Non-Material Amendment Report

14-19 Tottenham Mews

0475-CVA-RP-A-(PL)NMA-01 April 2024

Summary Overlay Diagram

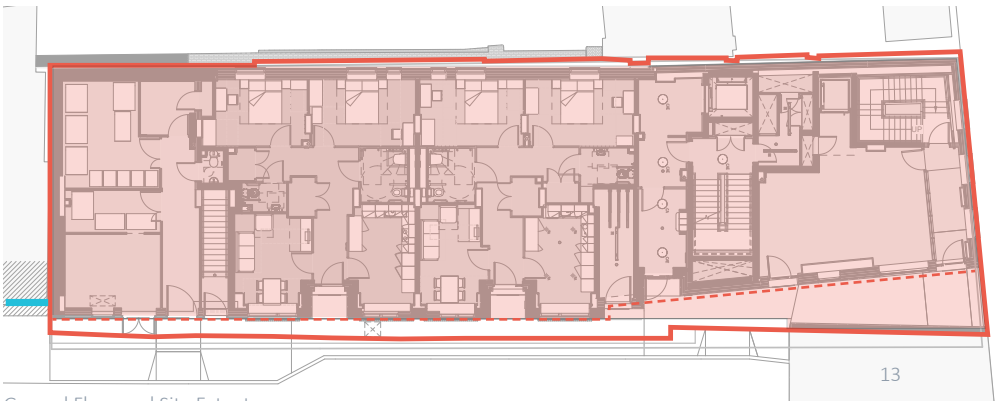
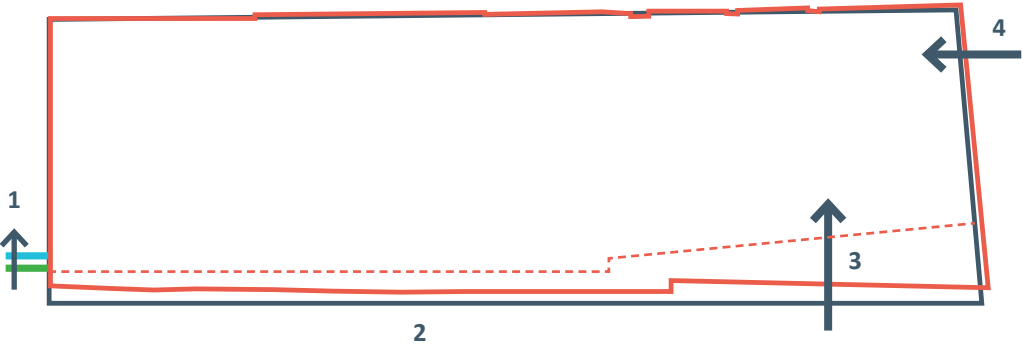
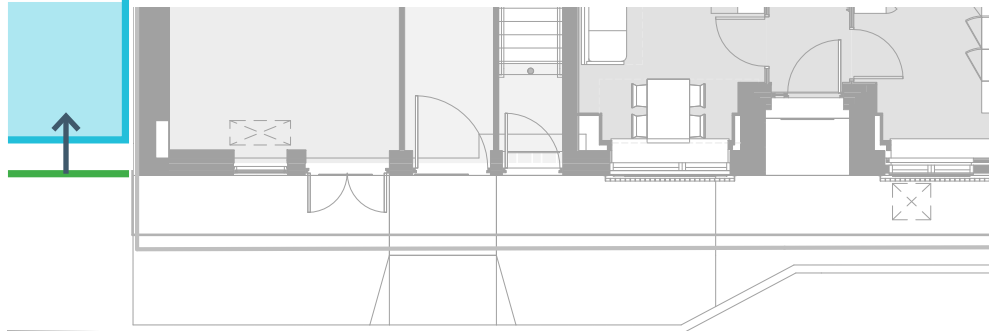
In April 2023, further to the demolition of the existing building on the 14-19 Tottenham Mews site, extensive surveys were commissioned by the current contractor to verify the site information. Discrepancies were identified and the footprint of the proposed building was modified to reflect the findings. An overlay of the consented scheme and the current proposal is presented in the diagrams, right.

The site was found taper along the northern boundary, the facade has been aligned to this new position which has reduced the area on all floors. In addition, a level change between the 14-19 Tottenham Mews site and the northern UCLH site has been identified. A slope has been introduced and the basement escape door has been relocated to the passage.

The surveyed position of 13 Tottenham Mews was found to be much further West than expected. In addition, structure along the passage, not illustrated in the original application, is necessary to support of the overhanging floors above. Overall this has contributed to a reduction to the width of the passage which will now be 1.7m wide at its narrowest. See section 2.2.

Ground Floor and Site Extents [excerpt]
Relationship with Arthur Stanley House

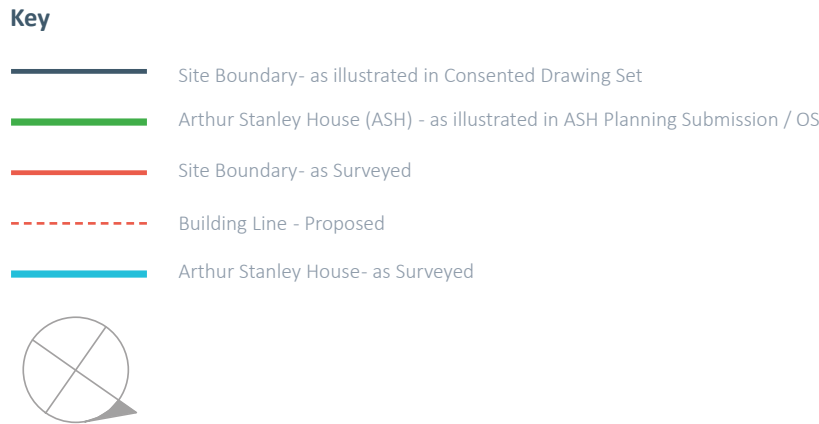
On the southern end of the building, Tottenham Mews is no longer proposed to sit flush with Arthur Stanley House. This is due to a change in the Arthur Stanley House building line since the original planning applications for both sites.

The green line documents the proposed building line of Arthur Stanley House (ASH), the light blue line illustrates the built line as surveyed on site earlier this year. There is a discrepancy of circa 600mm between the current proposed position of 14-19 Tottenham Mews and the as built position of ASH.

It is not possible to reduce the width of the proposal for 14-19 Tottenham Mews, from the consented scheme, to align with ASH without making the internal areas non-compliant. Camden LPA advised during the pre-planning process that this could be accepted with a brick finish to the protruding section of wall finished neatly against ASH.

It is also necessary to offer a small gap (circa 100mm) between the two buildings (from east to west) on account of a concrete upstand at ground level which sits on the ASH site.

Proposed Bedford Passage Link Partial Plan
Proposed Amendment

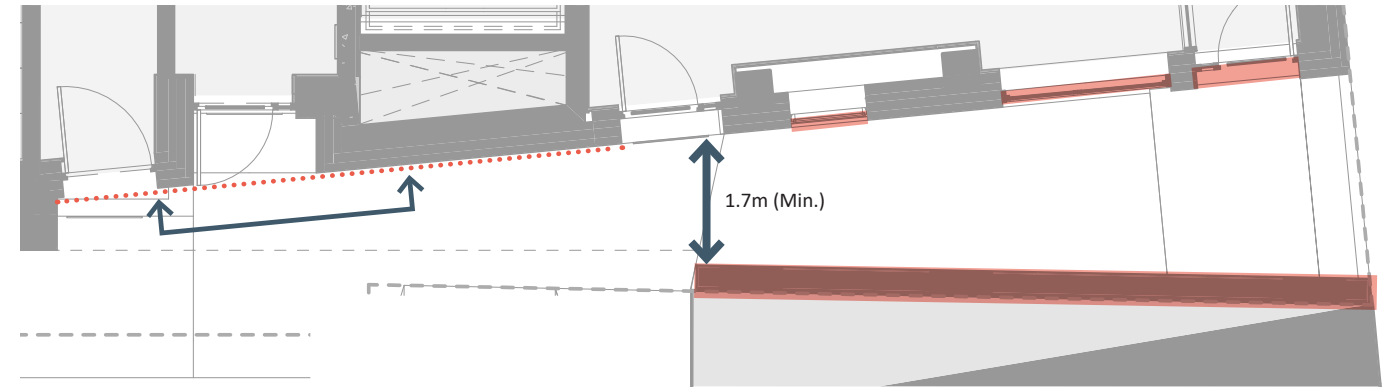
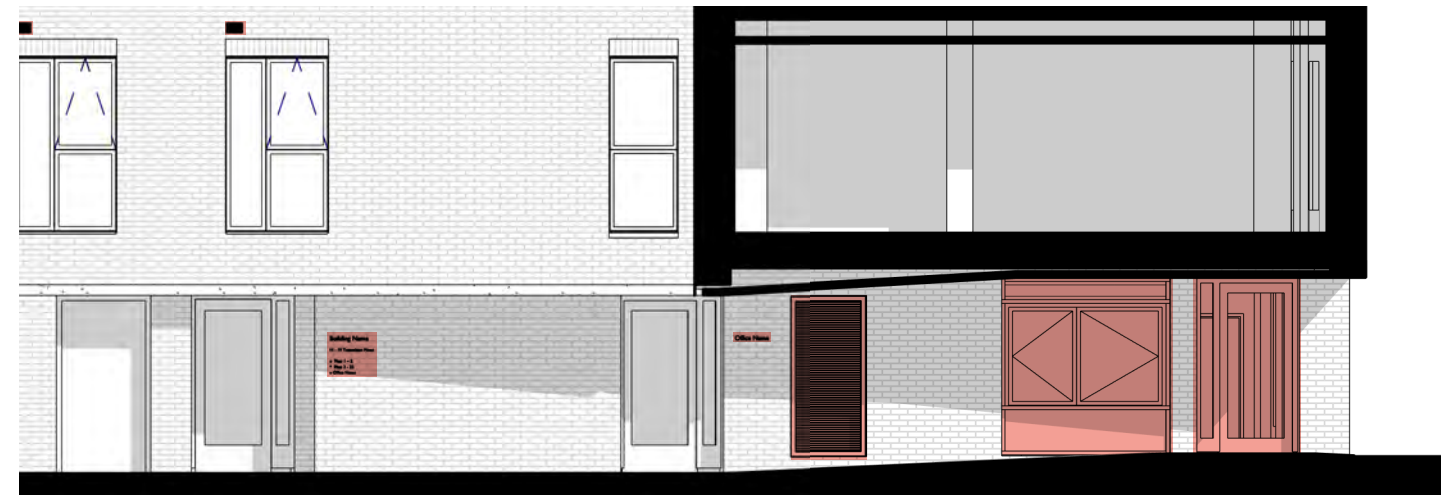
Through the pre-planning process, the sight line from Tottenham Mews through the newly formed link to Bedford Passage and vice versa have been carefully reviewed. The proposal initially presented has been modified to chamfer the corner of the building where it steps back around the cycle store, to match the chamfer of the office façade. It is unfortunately not viable to extend the chamfer through to the front wall of unit 00.1, discussed, without compromising the unit areas. The external lighting and CCTV strategy for this area will be carefully considered during the upcoming design stages to further improve visibility and safety.

Pavement lights to the basement are no longer required as part of the smoke ventilation strategy. It is proposed to omit these enabling an improved insulation and waterproofing detail to this area of the passage, which forms the roof over the basement office space. Natural and mechanical smoke shafts have been introduced as part of the smoke and fire strategy.

On account of the level change between the UCLH site and 14-19 Tottenham Mews, it is proposed to relocate the basement escape door to the eastern facade. Doing so will increase the amount of glazing along this facade providing increased overlooking of the passage. To the north, it is proposed to replicate the arrangement of the windows on level one at ground floor which will reflect more accurately the internal arrangement beyond and will work better with the planned cycle storage arrangement on the UCLH site.

Ground Floor Plan and Elevation
Proposed Amendment

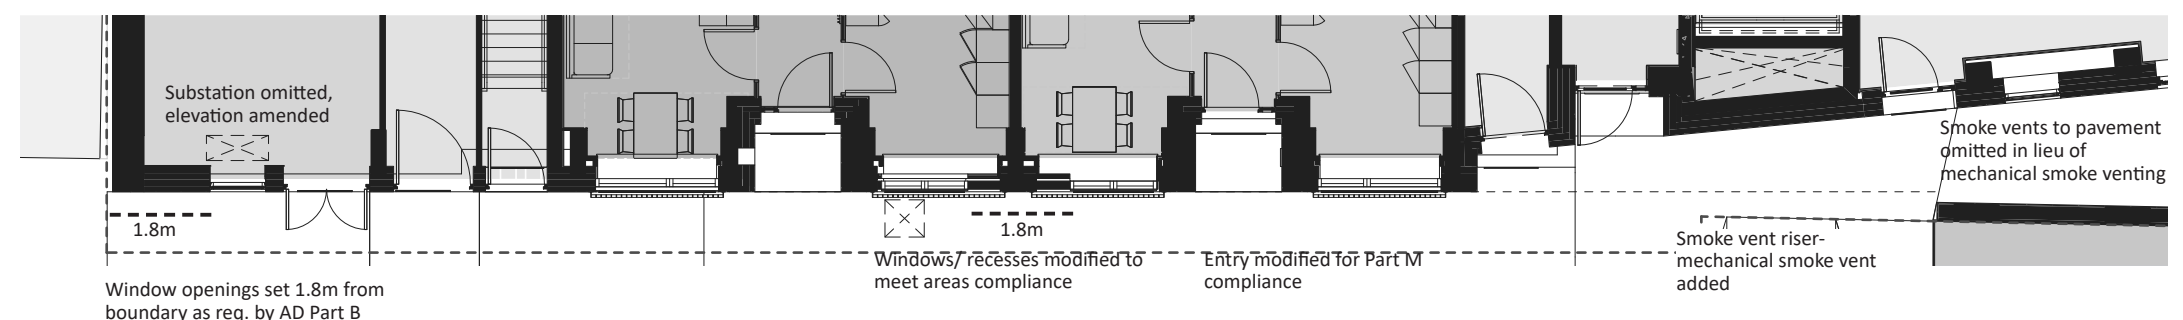
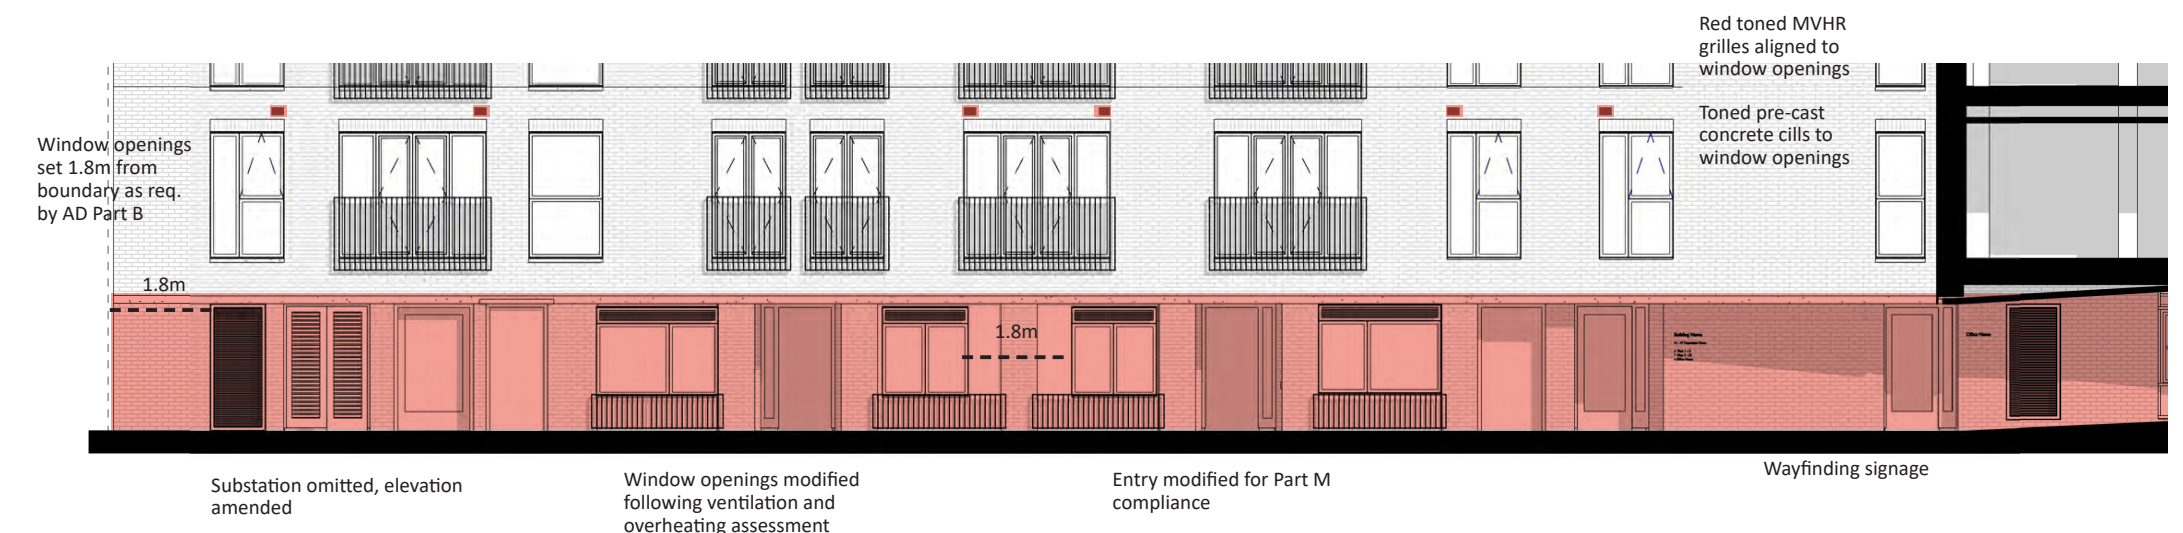
It has been necessary to adjust the window spacing from relevant boundaries and between different units to offer a minimum of 1.8m between unprotected areas for fire separation. In some areas, metal panelling has been introduced to avoid large, uninterrupted sections of masonry. The window heads have been adjusted and a louvred panel introduced where required to meet the requirements of the MEP strategy for ventilation. It will be necessary to locate all louvres and air bricks, **shown right**, on the East facade (to the mews) and the North facade only on account of unprotected area limitations on the West and South facade which abut boundaries.

The ground floor UKPN substation has been omitted and the plans and elevations have been modified to reflect this. Relocating the residential bin store to provide street access was discussed and reviewed but was found not viable on account of the plant replacement strategy requiring double doors with direct street access. **Following input from Camden LPA, a dedicated Bulky Waste area within the building has been allocated. The access door arrangement from the street has been adjusted to ensure 150mm clearance around a 1280L bin module to aid operatives with collection and return of units.**

It is necessary to omit the window recess to the M(4)3 units at ground floor to enable area compliance. The recesses were introduced previously to offer privacy to the bedrooms. We note that the internal layouts have been reconfigured so that these rooms are all now living/kitchen areas.
